# LYDIA LEIS ADDITION TO SEDGWICK COUNTY, KANSAS

RE: SUB 2002-67 -- One-Step Final Plat of Lydia Leis Addition

RE: SUB 2002-67 -- One-Step Final Plat of Lydia Leis Addition

**CASE NUMBER:** SUB 2002-67 -- LYDIA LEIS ADDITION

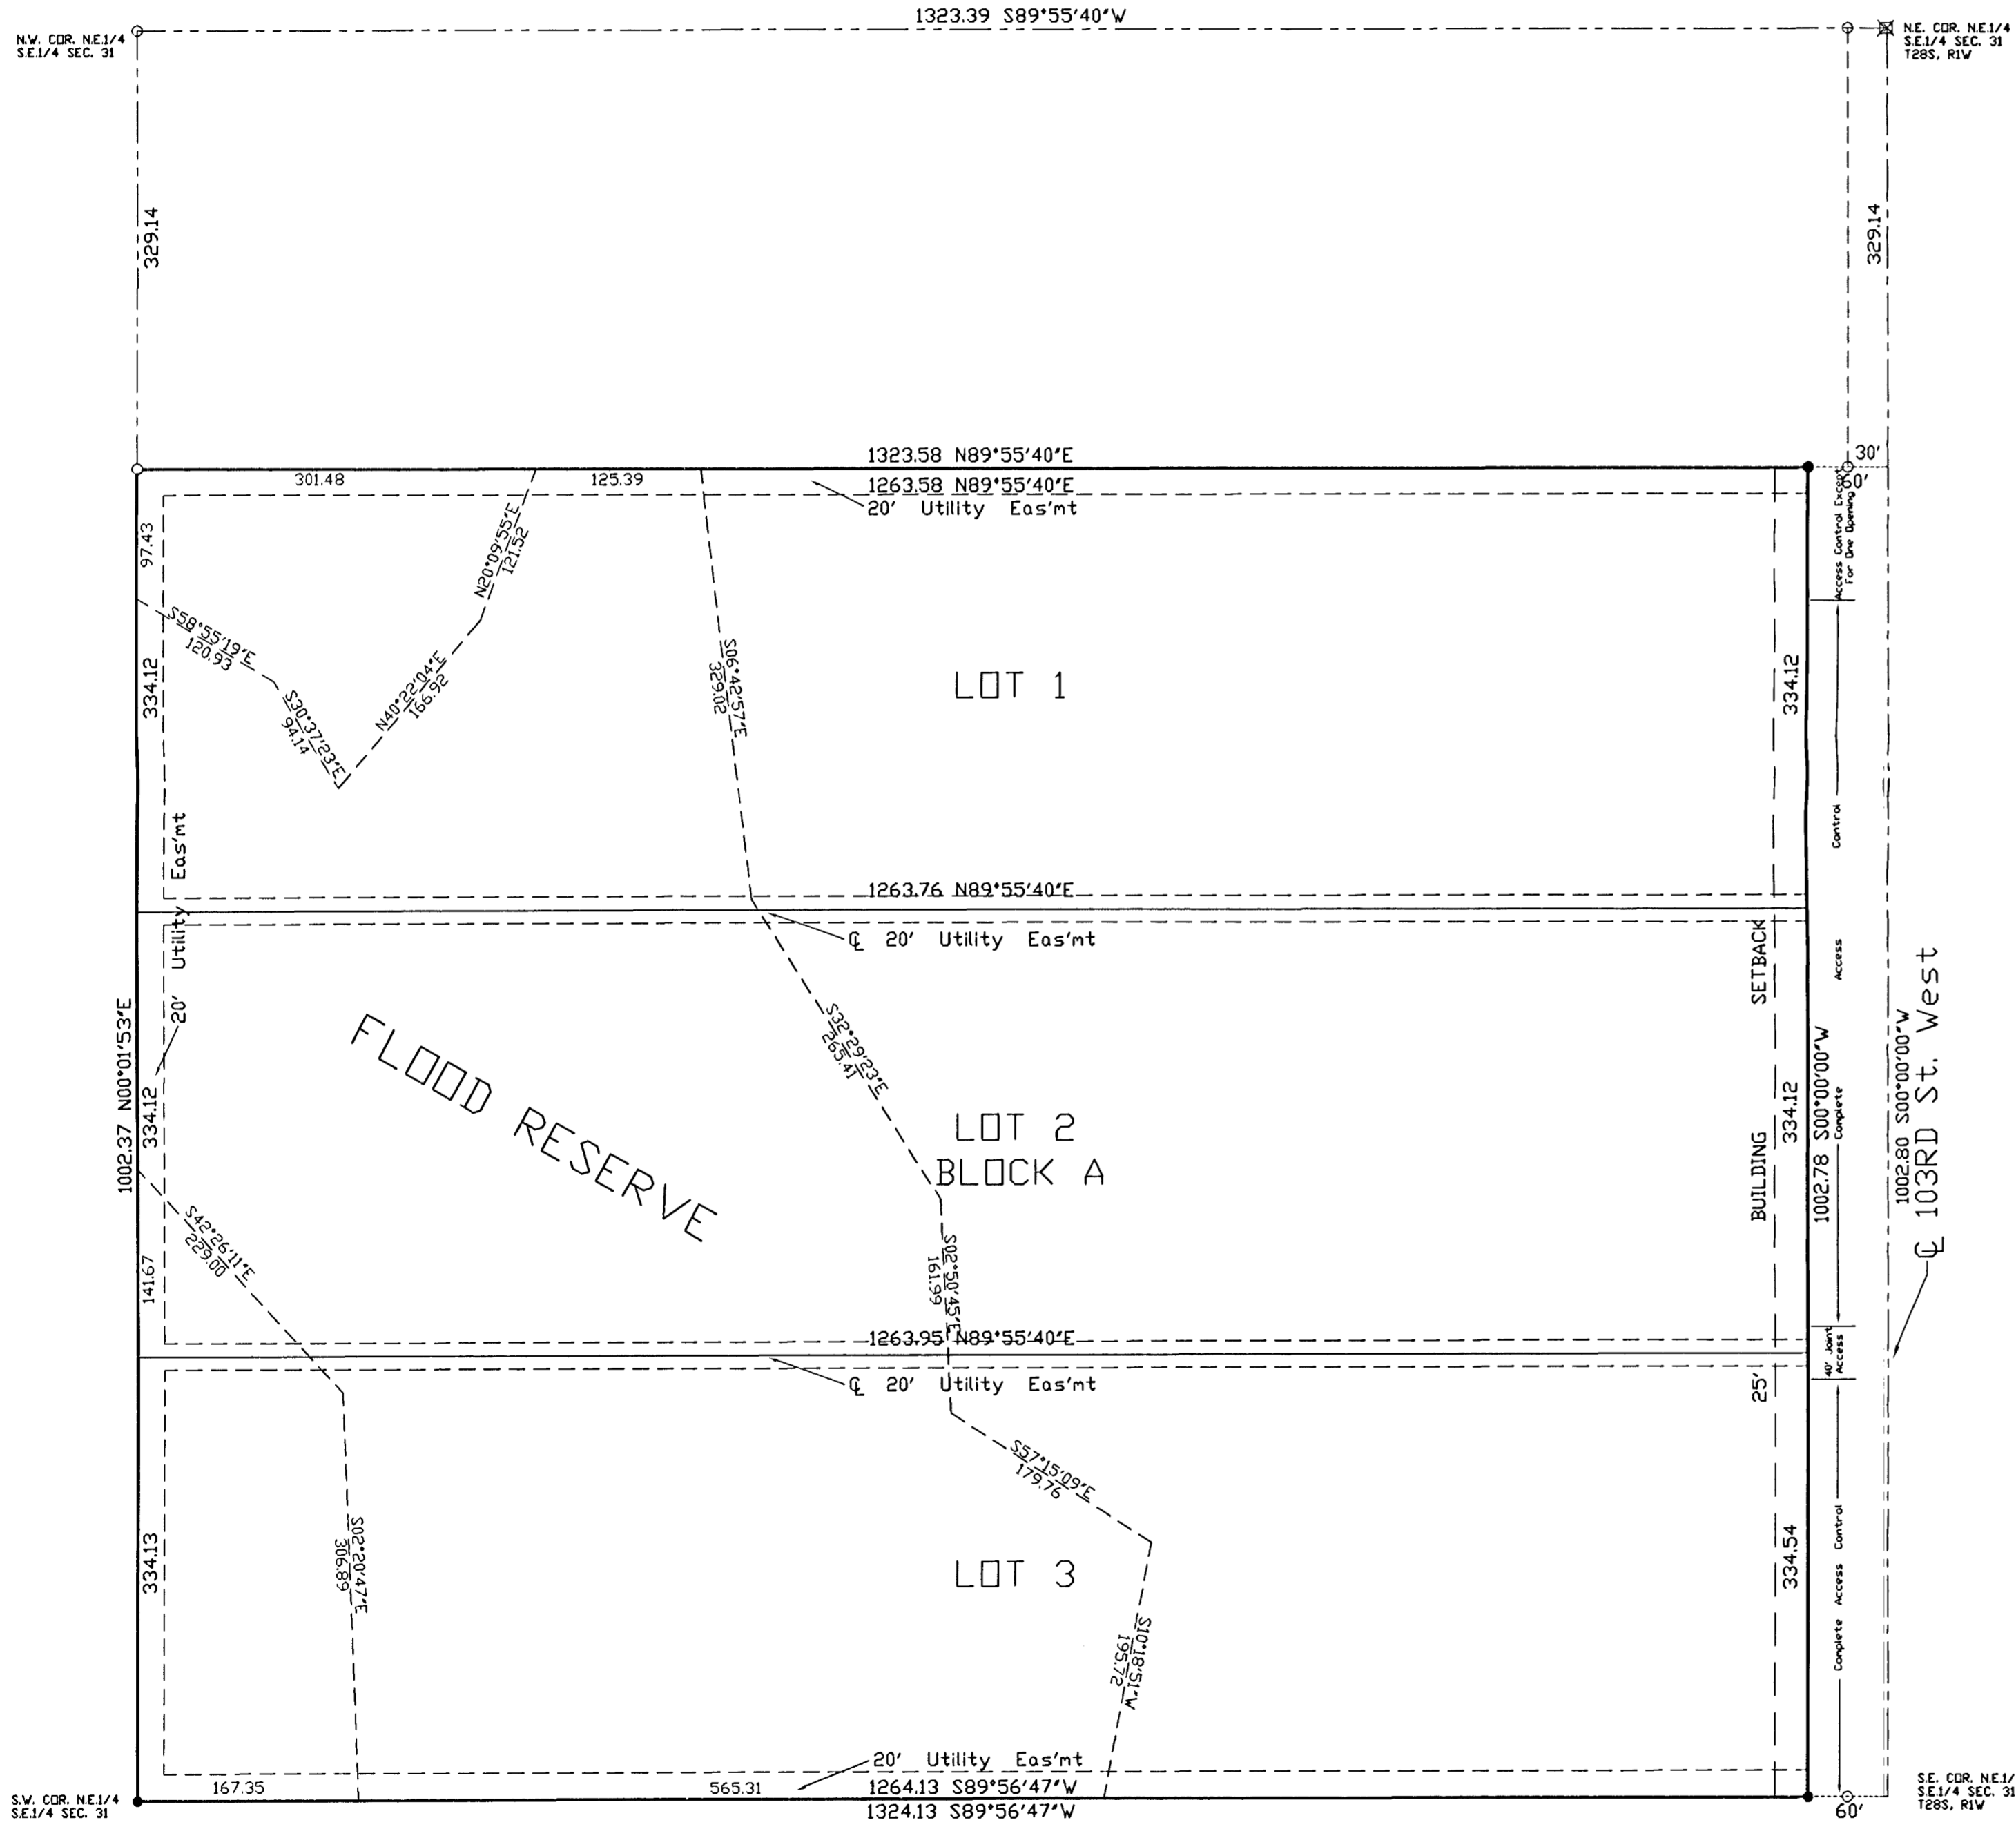
- D. **County Engineering** needs to comment on the status of the applicant's drainage plan. ***A drainage plan is needed. A floodway reserve needs to be platted.***

- E. **County Engineering** needs to comment on the access controls. The plat proposes two access openings along 103rd St. West, including one joint opening between Lots 2 and 3. ***Two openings have been approved. The opening for Lot 1 shall be located along the north property line.***

- H. On the final plat tracing, the MAPC signature block needs to reference "J.D. Michaelis, Chair".
- I. The signature line for the County Commissioners Chairman needs to reference "Ben Sciortino".

- J. The Applicant is advised that if platted, the building setbacks may be reduced to 25 feet to meet the 85-ft setback required from the centerline of County section line roads.

- K. Approval of this plat will require a waiver of the lot depth to width ratio of the Subdivision Regulations for all three lots. The Subdivision Regulations state that the maximum depth of all residential lots shall not exceed 2.5 times the width.

- L. The plat's text shall include language that a drainage plan has been developed for the plat and that all drainage easements, rights-of-way, or reserves shall remain at established grades or as modified with the approval of the applicable City or County Engineer, and unobstructed to allow for the conveyance of stormwater.
